CITY OF CODY
PLANNING, ZONING AND ADJUSTMENT BOARD
TUESDAY, FEBRUARY 24, 2015
CITY HALL COUNCIL CHAMBERS @ 12:00 NOON

MEETING DATE:	FEBRUARY 24, 2015	TYPE OF ACTION NEEDED	
AGENDA ITEM:		P&Z BOARD APPROVAL:	X
SUBJECT:	SITE PLAN REVIEW: WALMART LIQUOR BOX ADDITION SPR 2015-07	RECOMMENDATION TO COUNCIL:	
PREPARED BY:	TODD STOWELL, CITY PLANNER	DISCUSSION ONLY:

MEETING DATE:	FEBRUARY 24, 2015	TYPE OF ACTION NEEDED	
AGENDA ITEM:		P&Z BOARD APPROVAL:	X
SUBJECT:	WELLS FARGO ATM KIOSK/SIGN DOWNTOWN ARCHITECTURAL DISTRICT REVIEW. SGN 2015-01	RECOMMENDATION TO COUNCIL:	
PREPARED BY:	TODD STOWELL	DISCUSSION ONLY:

MEETING DATE:	FEBRUARY 24, 2015	TYPE OF ACTION NEEDED	
AGENDA ITEM:		P&Z BOARD APPROVAL:	X
SUBJECT:	SITE PLAN REVIEW—OUTSTANDING ITEMS FOR FEDEX GROUND FACILITY SPR 2014-36 (CONTINUED)	RECOMMENDATION TO COUNCIL:	
PREPARED BY:	TODD STOWELL, CITY PLANNER	DISCUSSION ONLY:

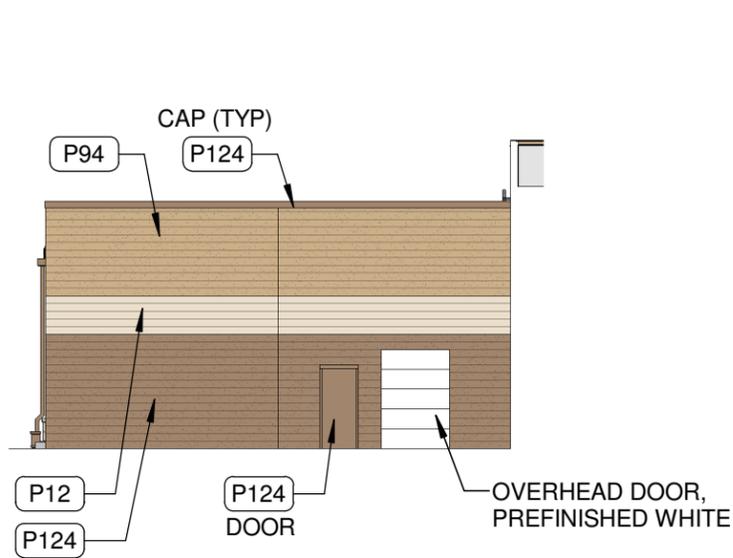
One modification to the parking along the east side of the liquor box is requested. For ADA purposes, the two southernmost parking spaces should be restriped to provide a single van-accessible ADA parking space. A sign post for the space will also need to be added. (Note: Mounting height of the sign need only be 5', not 7' as shown on sheet SD7.) The ADA route from the ADA parking space to the liquor store will be provided by the new ramp just south of the van accessible space.

- 1) Provide a van-accessible ADA parking and loading space in the parking area nearest the sidewalk ramp.

A2.0

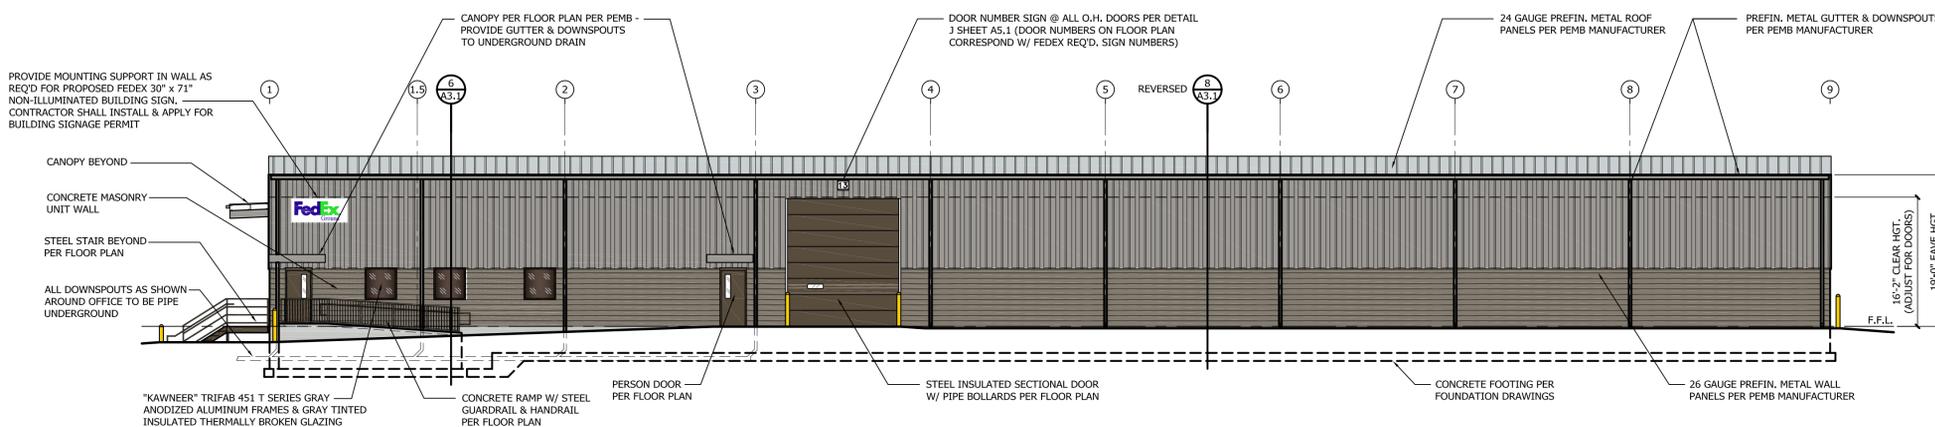
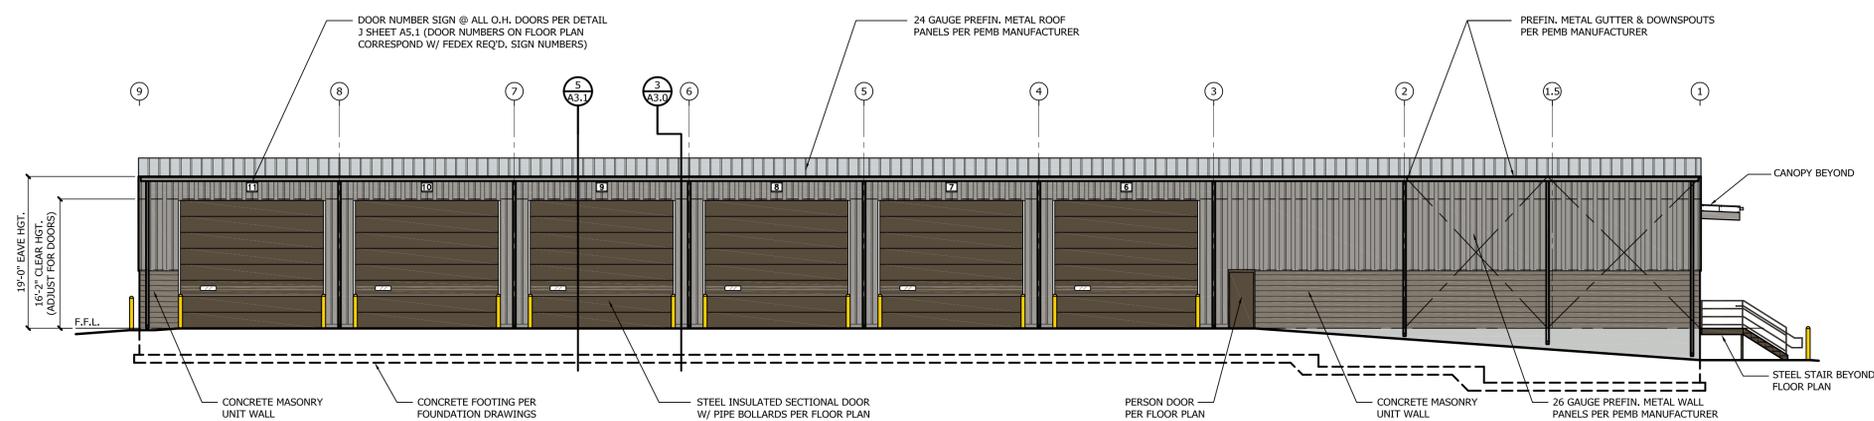
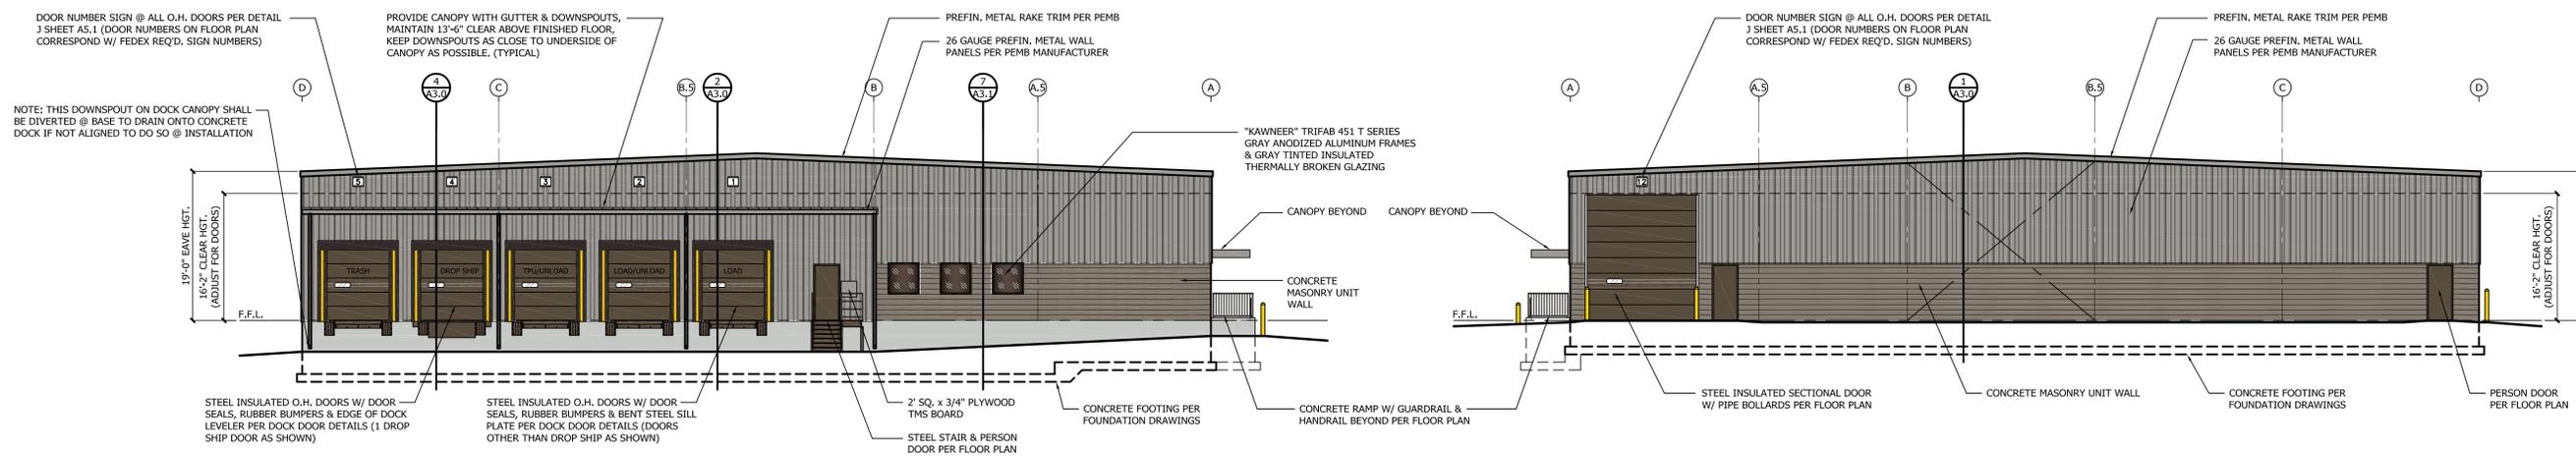
4. **Masonry Requirement:** The P&Z Board specified a minimum of 25% masonry on the exterior walls of the building. The plans have been revised, but are about 17 linear feet short of meeting the 25% requirement.

Staff Comment: The masonry now forms a wainscot around all of the building, except at the overhead doors. Staff believes the intent of the requirement has been met.

5. **Overhead Door Color:** As required by the P&Z Board and to address the concerns of the adjoining property owners, the applicant has changed the color of the overhead doors. The building colors are shown on the architectural rendering.
6. **Irrigation Plan:** The landscape subcontractor is yet to complete the irrigation distribution plan and will have it submitted for approval prior to installation of any landscaping.
7. **Height of exterior light poles:** The lighting contractor is asking the P&Z Board to reconsider their decision to limit total height of all exterior lights to 33 feet. The current plans show three of the light poles extending 42 feet in height.

PRELIMINARY SITE LANDSCAPING PLAN
PROPOSED FEDEX GROUND FACILITY
Ruedeusch Development & Construction, LLC
33rd Street and Cougar Avenue
Cody Wyoming

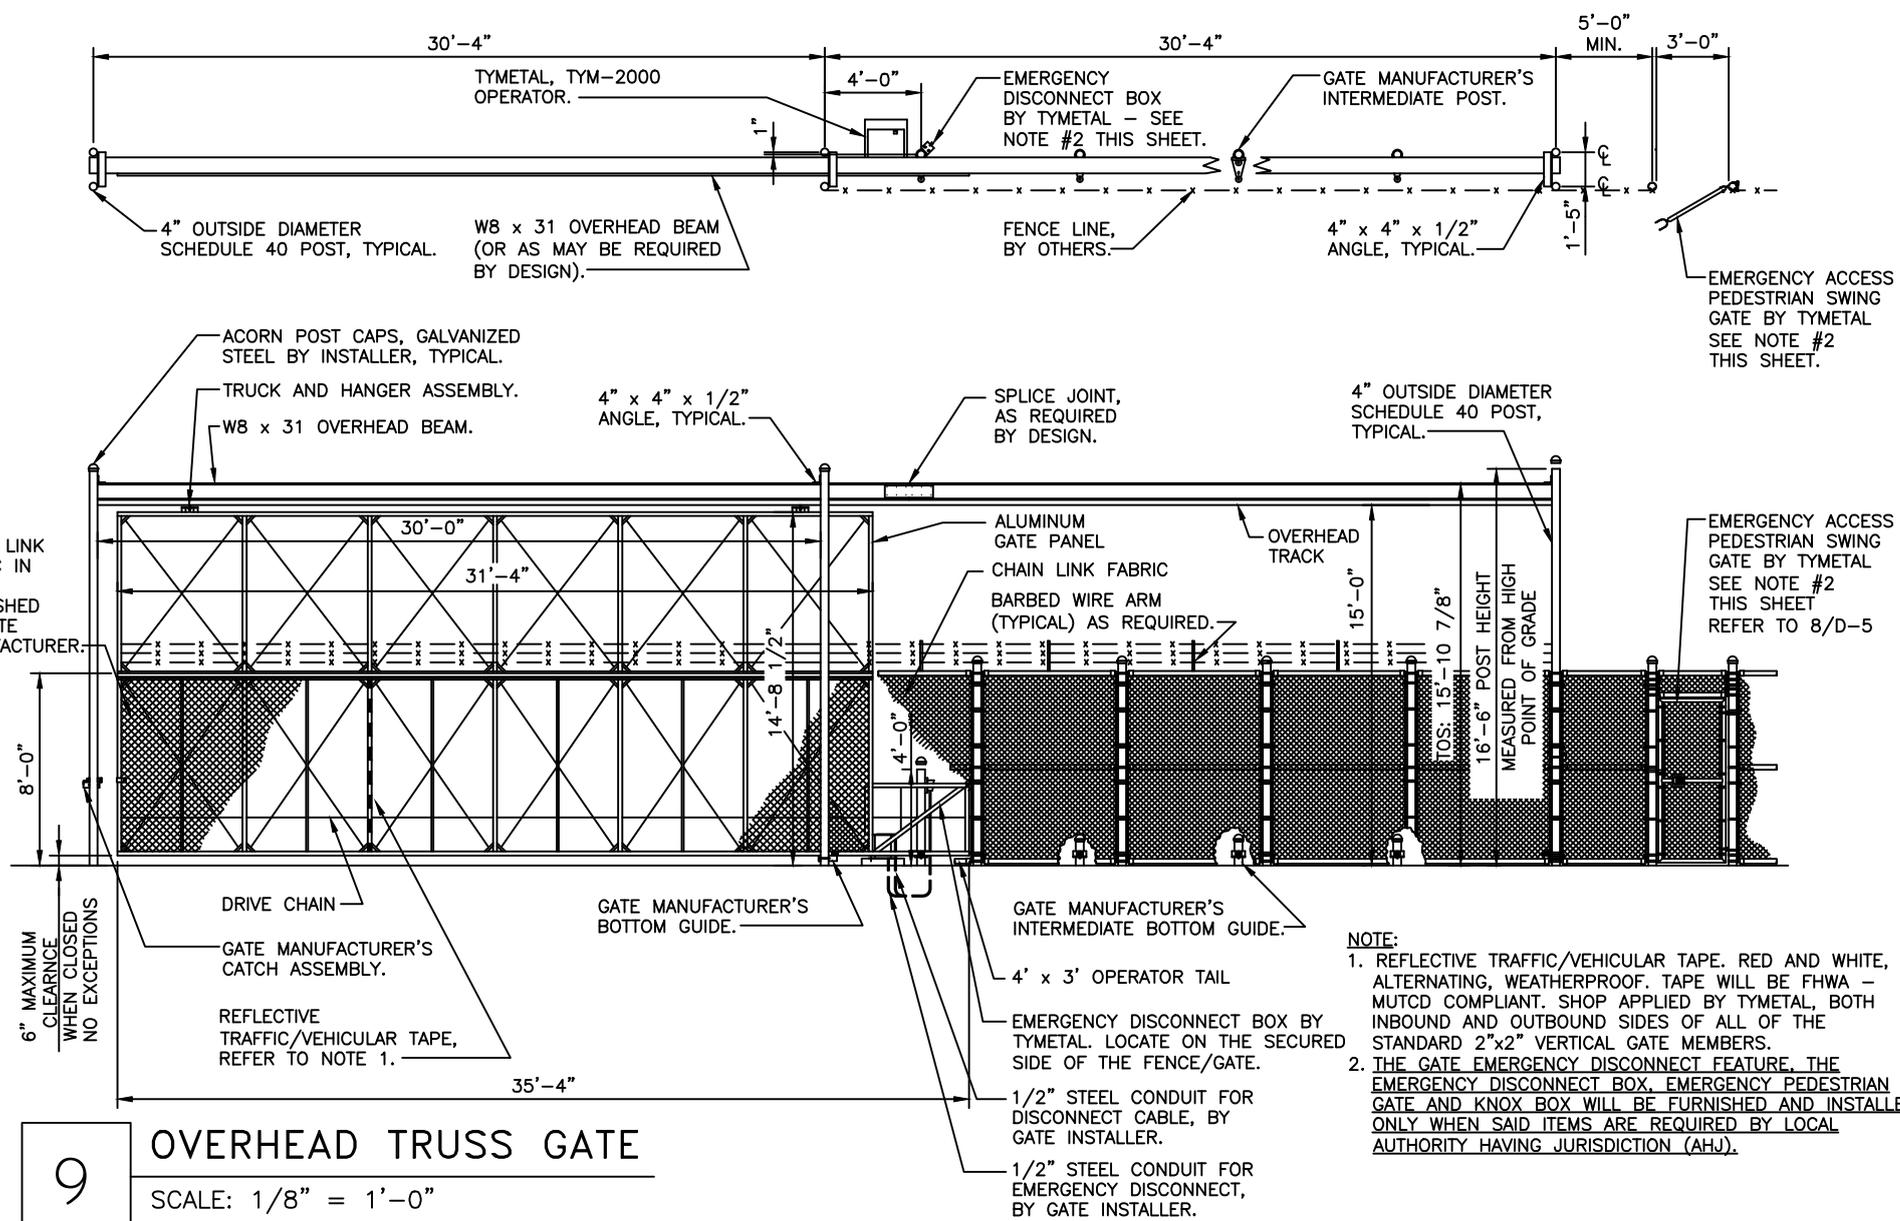
1. Landscaping Plan: In response to neighbor concerns, the number of trees has been increased and the variety of tree changed to Rocky Mountain juniper along the west side of the project and Colorado blue spruce elsewhere.

Staff Comment: The additional trees are appreciated. As the P&Z board specified previously, minimum height at planting is to be at least eight (8) feet above ground level. The landscaping plan is slightly misleading, in that the diameter of the trees are likely exaggerated—Colorado blue spruce has a mature diameter of only about 20 feet in landscapes, while the trees on the plan scale at about 30 feet in diameter and are spaced about 55 feet on center. A true “screen” would require the trees to be planted 15-20 feet apart. The screening effect is also hampered by the grading of the site, as the trees are three to seven feet in elevation lower than the elevation of the building floor. Staff is not saying that more trees are necessarily needed, but we want the Board to understand the situation.

9 OVERHEAD TRUSS GATE
 SCALE: 1/8" = 1'-0"

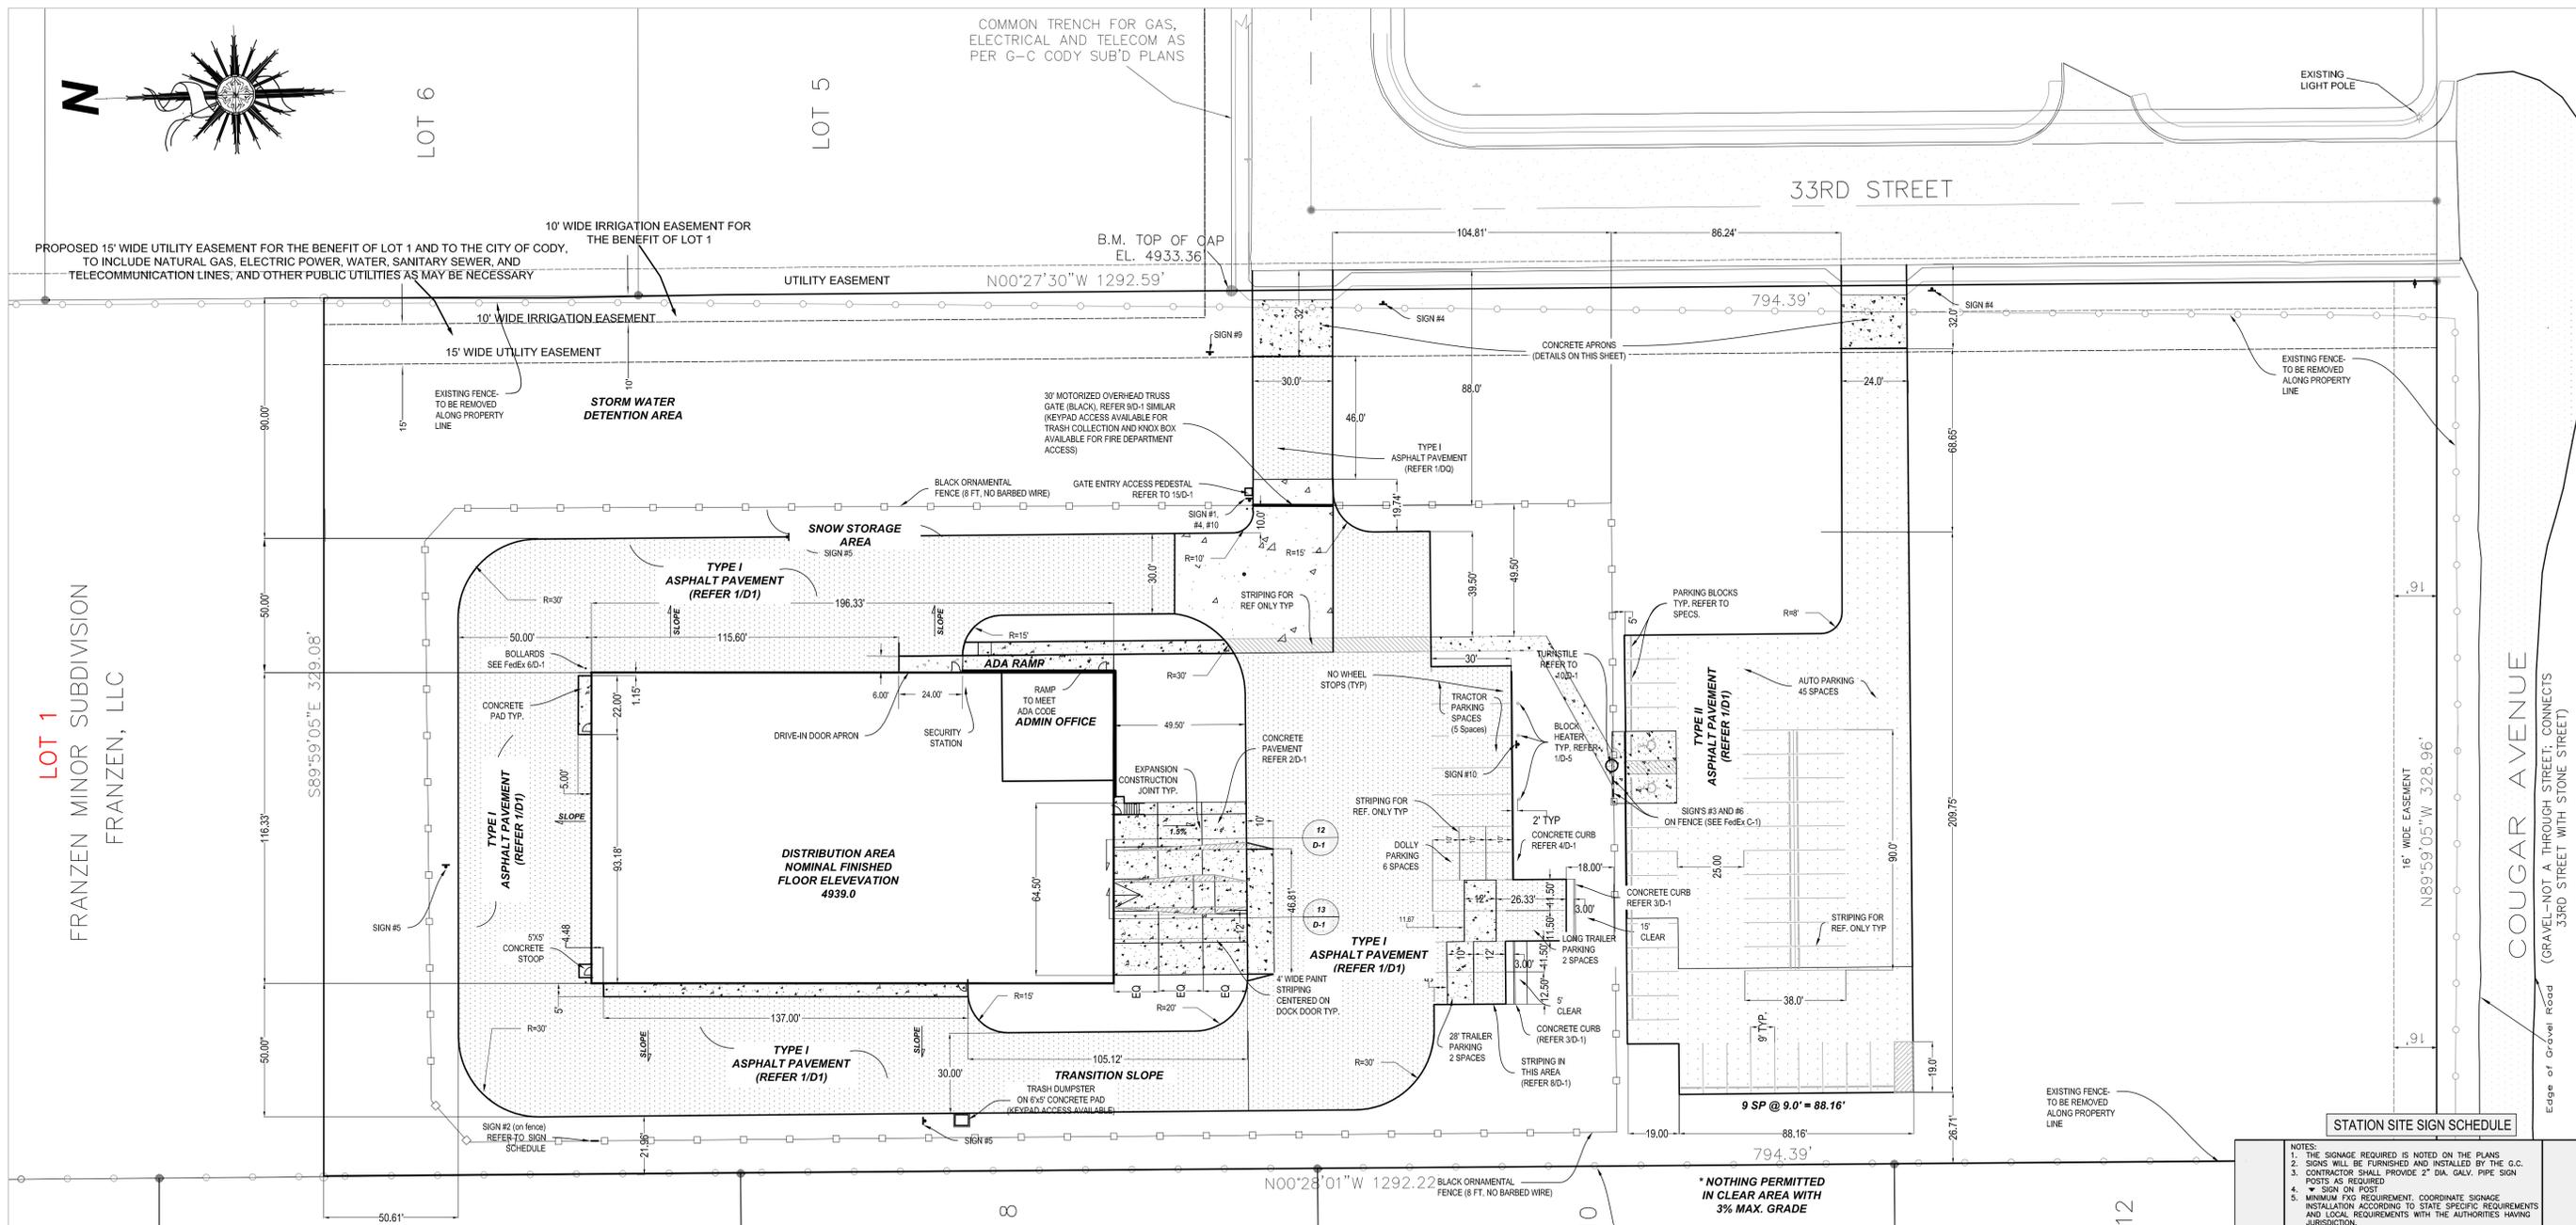
3. Entrance Gates: The P&Z Board did not approve any fence or gate over six feet tall in their prior reviews. The standard entrance gate structure is shown on Detail 9 of Sheet D-1, and measures almost sixteen feet tall and sixty feet wide. There is also a turnstile and employee pedestrian gate that would be about eight feet tall. The yard entrance gate, turnstile and employee entrance gate will be painted black to match the perimeter fence. The applicant is requesting permission for the entrance gates as proposed.

Staff Comment: Eight feet for the turnstile and pedestrian gate seem reasonable, as that is the same height as the requested fence. The applicant has not provided any justification for the height and style of the vehicle entrance gate other than to note that it is the standard. It would seem that an eight foot tall gate structure would suffice, as it provides the same level of security as the rest of the perimeter barrier fence.
